Subject: Intermountain Power Agency (IPA) – Permit Change, Proposed Permit  
Boundary and Disturbed Area Increase  
Wildcat Loadout Facility, C/007/0033

## APPLICATION FOR COAL PERMIT PROCESSING

**Title:** PROPOSED PERMIT BOUNDARY AND DISTURBED AREA EXPANSION

## Detailed Schedule Of Changes to the Mining And Reclamation Plan

REVISION NUMBER:	4	SCALE:	1" = 800'
DATE:	JUNE 2014		PLATE 11

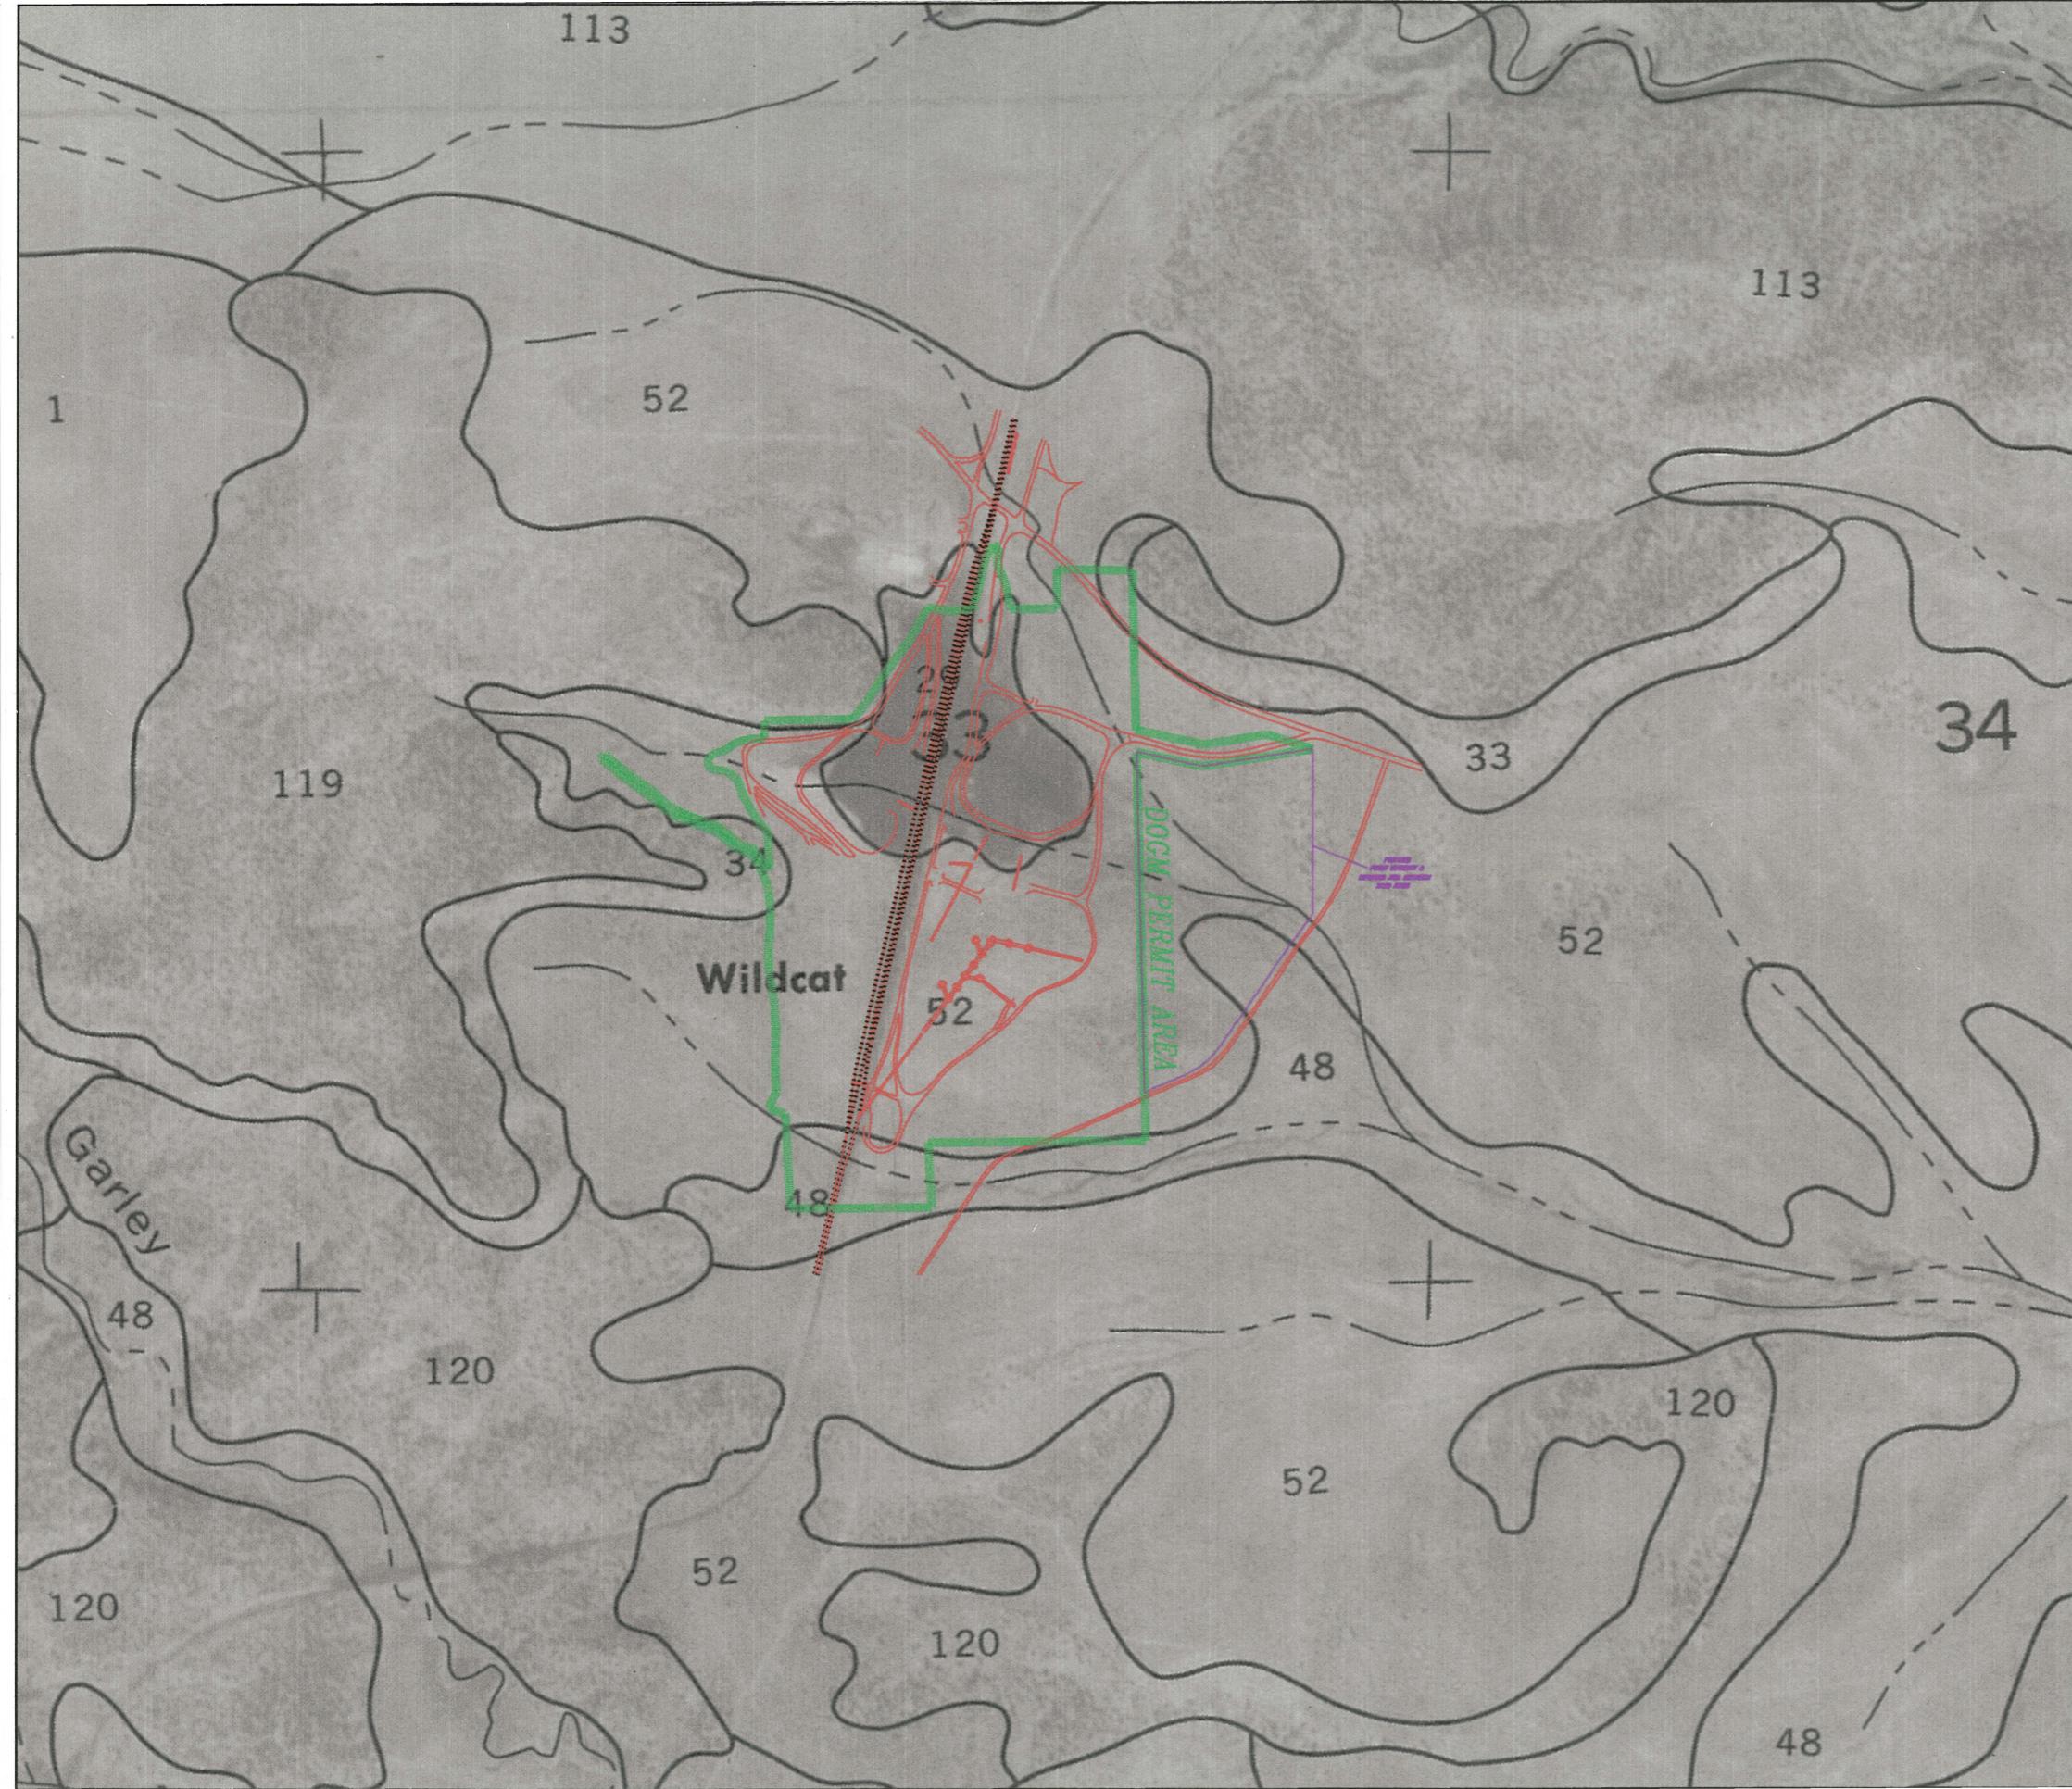
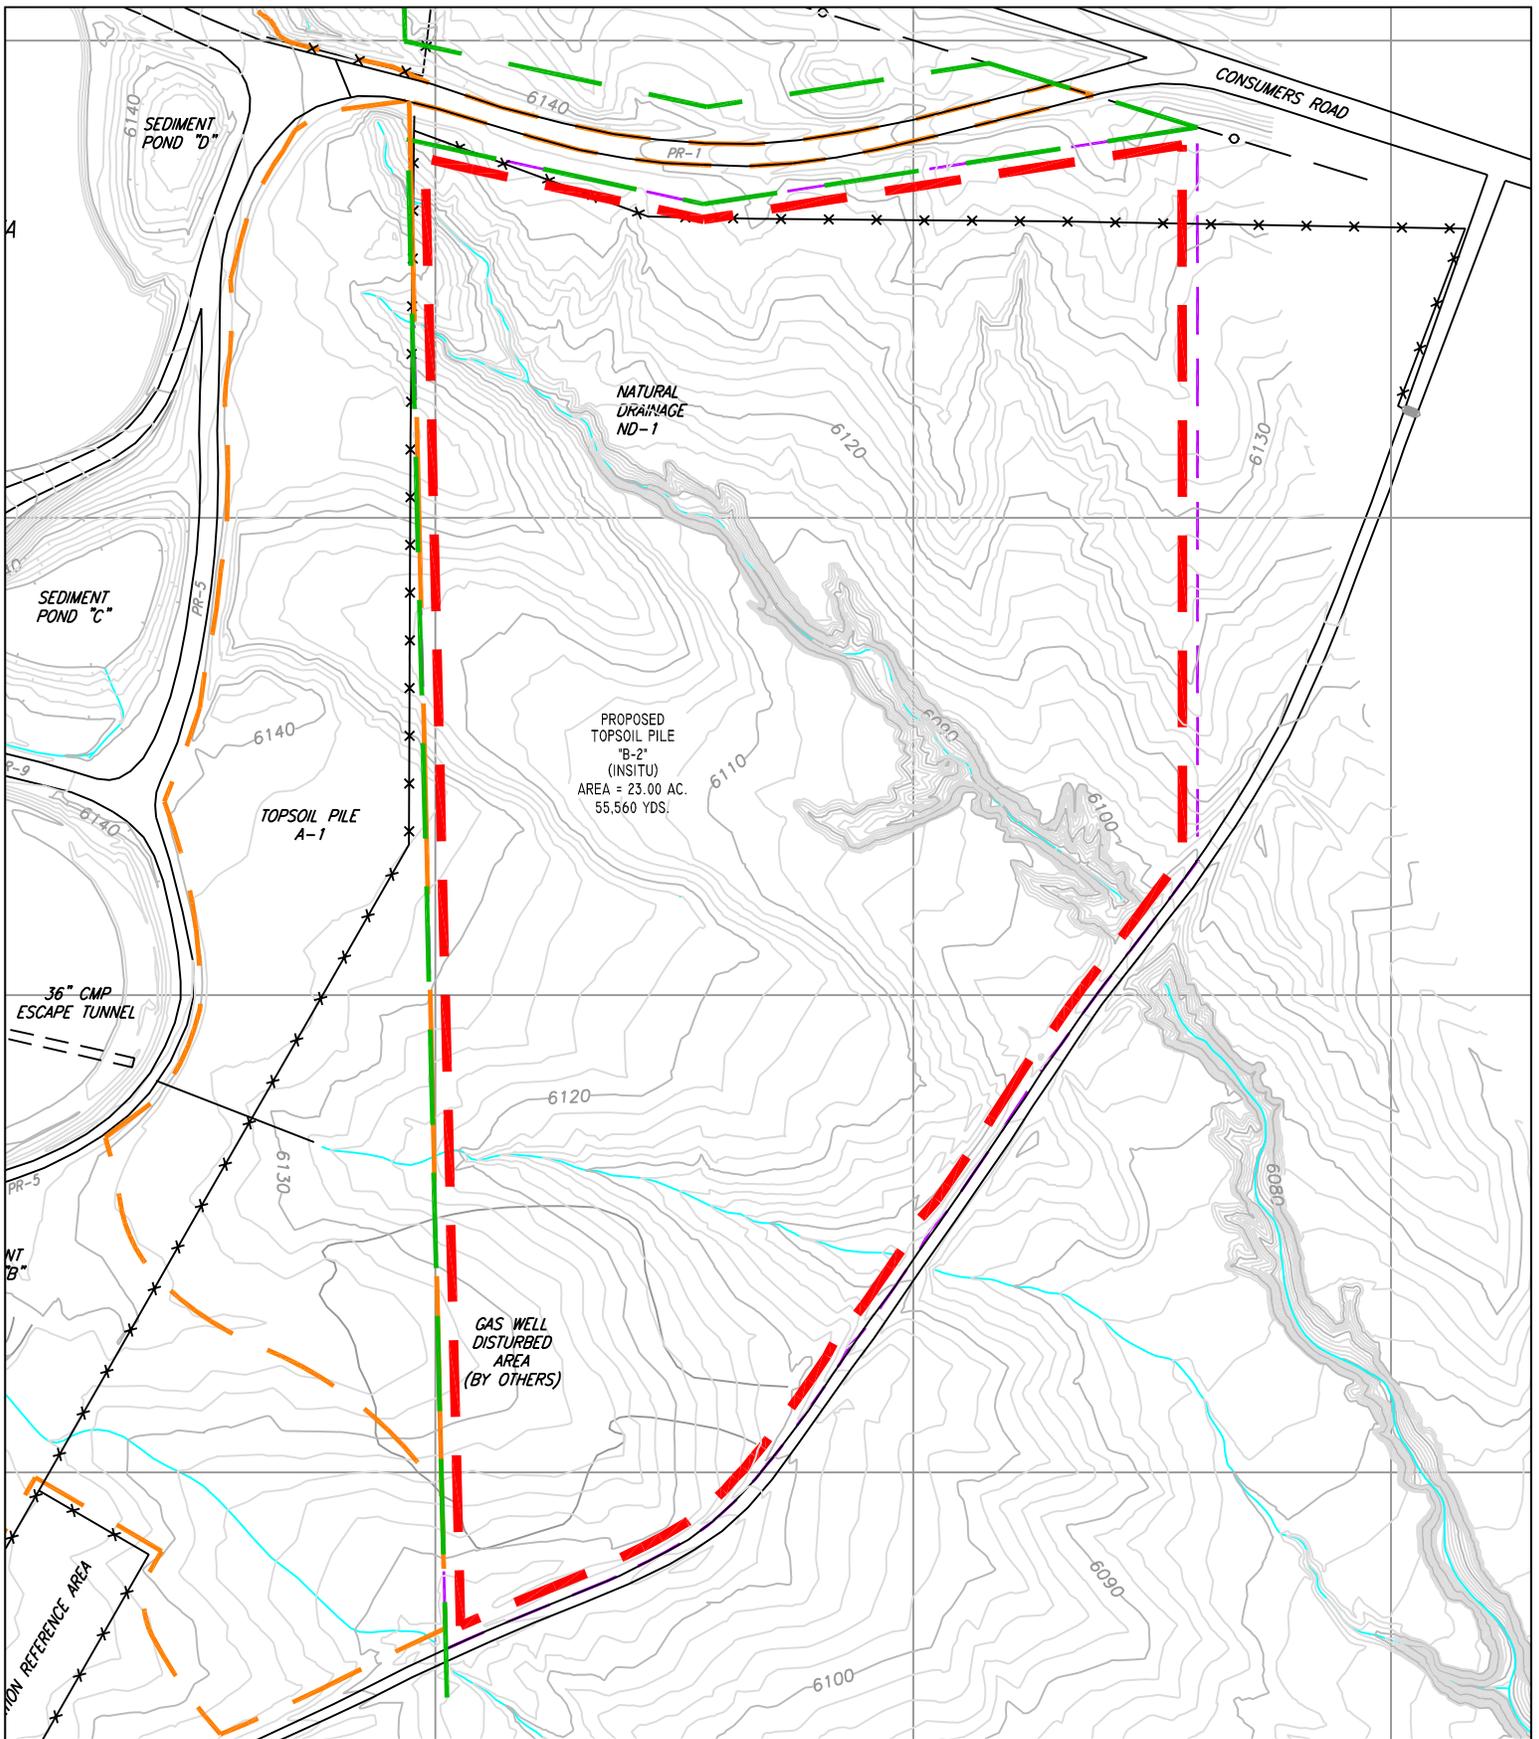
To prevent further issues from potential wind blown and waterbourne fines, IPA is requesting to increase the existing permit area and disturbed area by approximately 23 acres. As discussed with the Division's soil scientist, Priscilla Burton, it was suggested that this proposed expansion area also be considered as an "insitu" topsoil pile (B-1) and no additional soil survey will be required unless construction activities or other significant disturbances are performed. This area was also included in the 2003 soil survey. (Refer to Appendix D and Plate 11-Soils Map). (Topsoile piles are located on Plates 13a and 13b).
